(122<sup>nd</sup> WP.29, 7-10 November 2000,  
Agenda item 6.12.)

**PROPOSED AMENDMENTS TO REGULATION NO. 52**

(Small capacity public service vehicles)

Transmitted by the representative of Poland

Annex 3, Figure 1, amend as following:

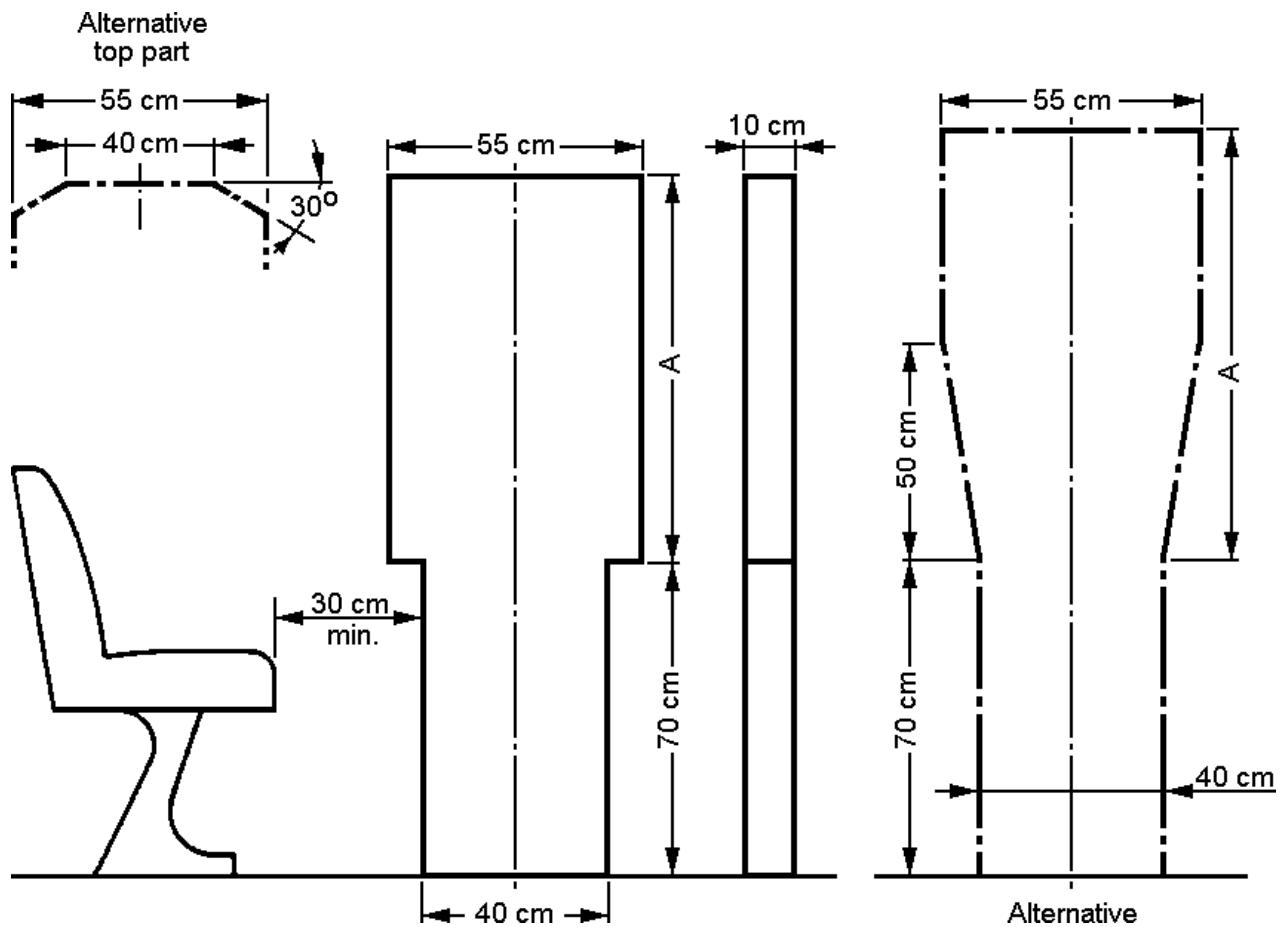
The "alternative top part" which is described in the third subparagraph of paragraph 5.7.1.1. was not shown on the figure 1 of Annex 3, as referred to.

Annexe 3, figure 1, modifier comme suit :

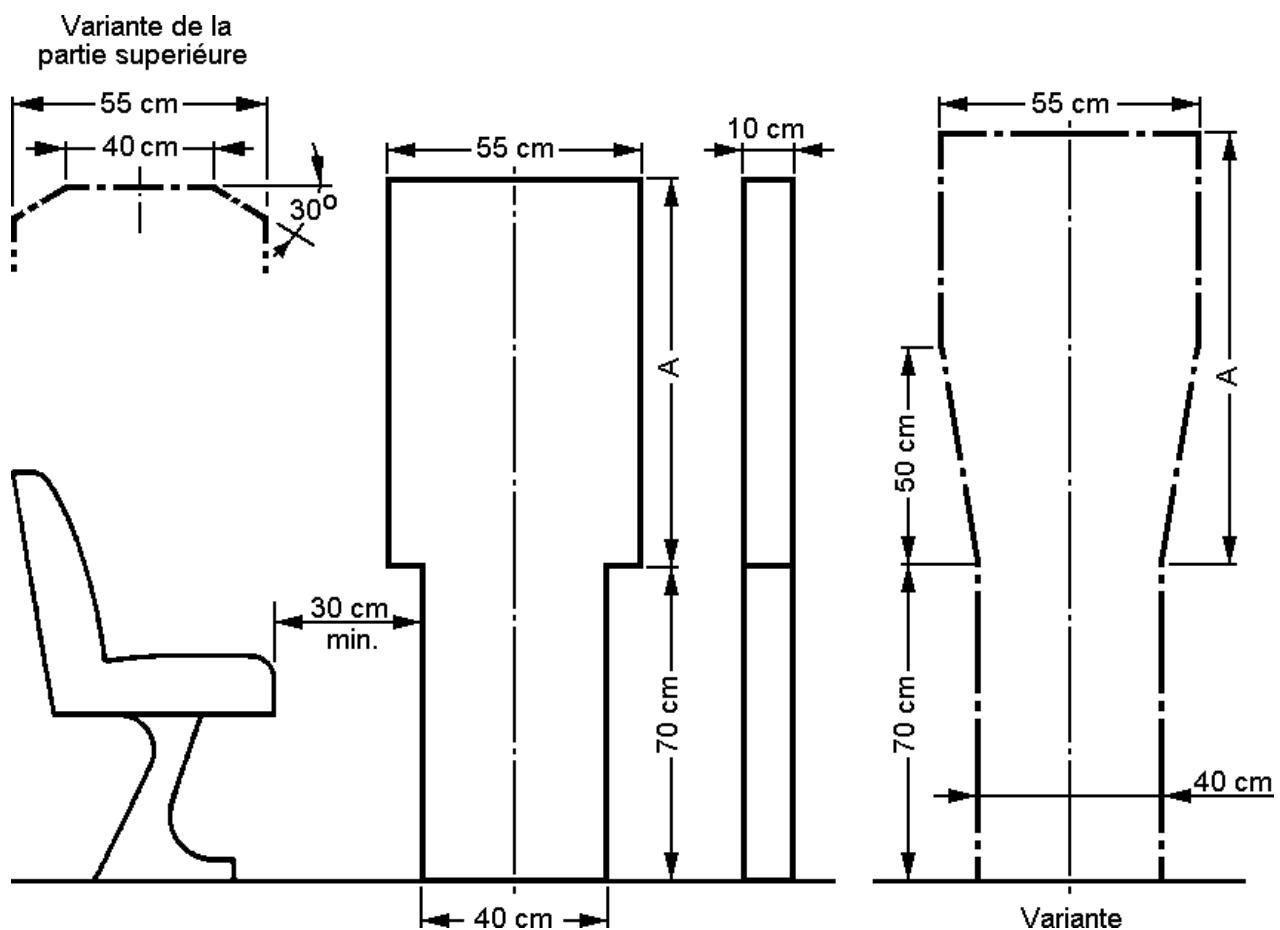
La "variante de partie supérieure" qui est décrite au troisième alinéa du paragraphe 5.7.1.1. n'est pas inclue dans la figure 1 de l'annexe 3.
